**MONTGOMERY COUNTY HISTORIC PRESERVATION COMMISSION**  
**STAFF REPORT**

<b>Address:</b>	4701 Waverly Avenue, Garrett Park	<b>Meeting Date:</b>	1/21/2026
<b>Resource:</b>	Outstanding Resource (Garrett Park Historic District)	<b>Report Date:</b>	1/14/2026
<b>Applicant:</b>	Leslie Ogus	<b>Public Notice:</b>	1/7/2026
<b>Review:</b>	HAWP	<b>Tax Credit:</b>	No
<b>Permit Number:</b>	1143790	<b>Staff:</b>	Devon Murtha
<b>Proposal:</b>	Partial demolition and construction of screened in porch

**STAFF RECOMMENDATION**

Figure 4: Elevation drawings of the proposed screened porch (left) and site plan showing proposed location (right). The screened porch is annotated with a red square.

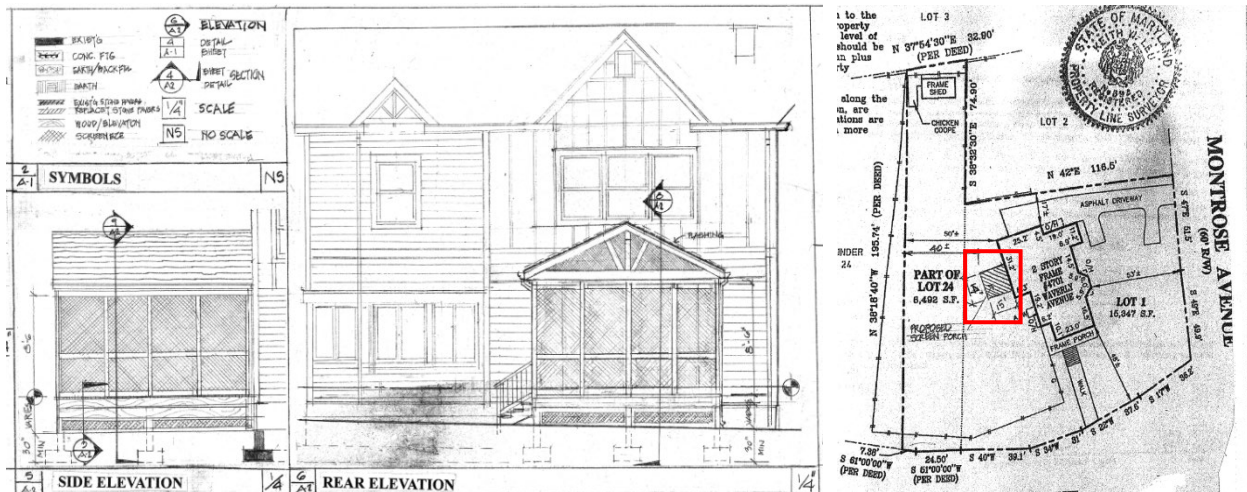
Staff finds that the overall location, massing, and form of the porch is compatible with the character of the district, per Chapter 24A(8)(b) and the *Standards*. The porch will be constructed off the non-historic rear addition, and, per Standard 9, it will not destroy any historic materials, features, and spatial relationships that characterize the property. Due to the large lot size and corner location, the porch will be visible from the right-of-way along Waverly Avenue; however, Staff finds that that the simple gabled-roof design and small footprint of the porch will not detract from or compete with the historic block of the house (*Figure 6*).

According to *Policy 24-01*, all porches and decks on Outstanding Resources should be wood; however, porches on building additions and new construction to Outstanding/Primary resources will be evaluated on a case-by-case basis. Staff has not seen a sample of this material installed and cannot determine whether it meets the criteria for a compatible substitute material under *Policy 24-01*. Staff finds that, in this case, a non-compatible substitute material is still appropriate due to limited visibility of the decking material and the location of the proposed deck. The porch will be enclosed, so the surface texture of the material will be highly obscured. Additionally, the decking is set back substantially from the right-of-way on a side elevation, further limited the material visibility and impact to the district.

1. The applicant must not use vinyl railings.
2. The applicant must not install composite decking for the stairs. The stairs must be wood.
3. A trim board must be installed perpendicular to any composite decking edges.
4. The applicant must submit comprehensive updated materials specifications that are compatible with the district prior to issuance of final approval documents, including specifications for the proposed door.
5. The proposed Screenshot system must be installed flush mounted.
6. The existing fiber cement siding material on the historic house is not eligible to be replaced in-

*Figure 8: Detail showing the exposed composite decking (left) and examples image showing the correct installation of a finishing board to hide edges (right; Wolf Home Products).*

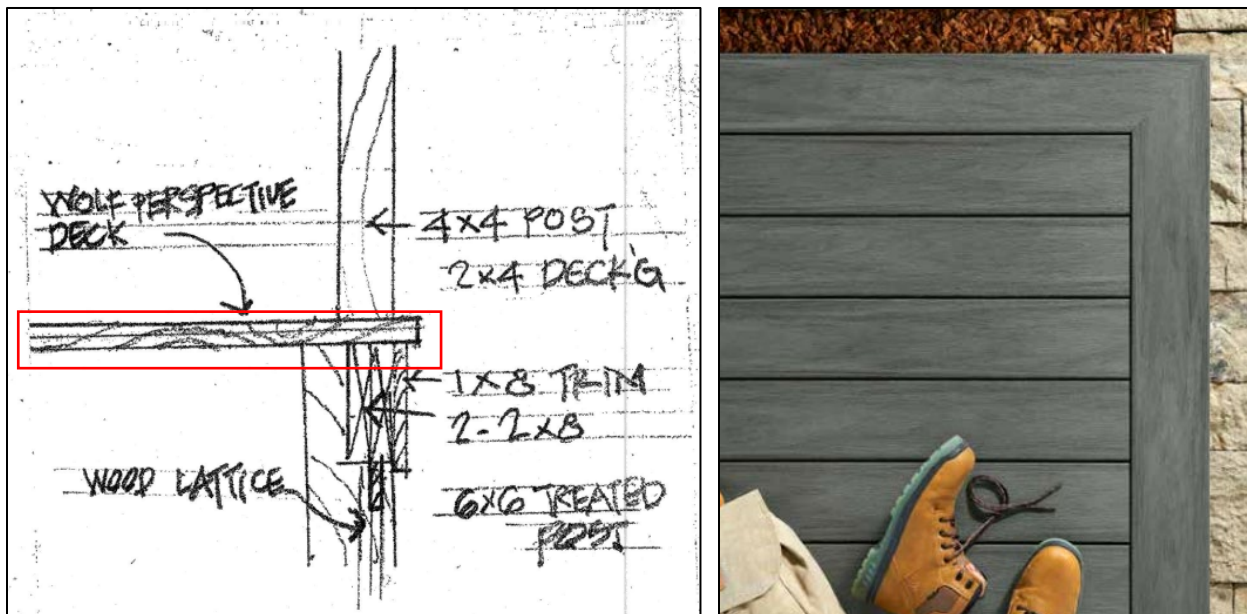
Staff notes that the decking may be visible in some areas underneath the screening. The edges of composite decking are generally not consistent with the appearance of wood and should be finished with a board to conceal the edges (*Figure 8*). Staff notes that this the examples on the manufacturer website show this installation method (*Figure 8*).

Figure 9: Screenshot system details.

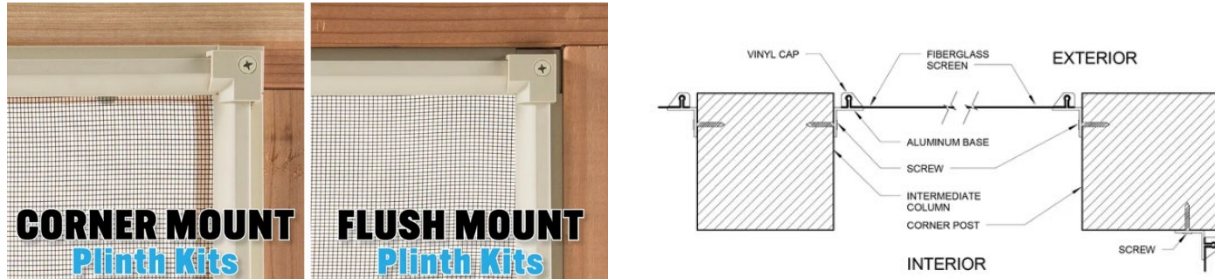
Based on the drawings, Staff understands that the framing material for the porch will be wood. Staff notes that any non-wood trim or cladding must be submitted for review prior to issuance of final approval documents. The proposed Screenshot system has a small aluminum/vinyl frame. Staff finds that the profile is small enough to have no material effect on the porch, but should be installed flush mounted, as opposed to corner mounted, to not draw additional emphasis to the frames.
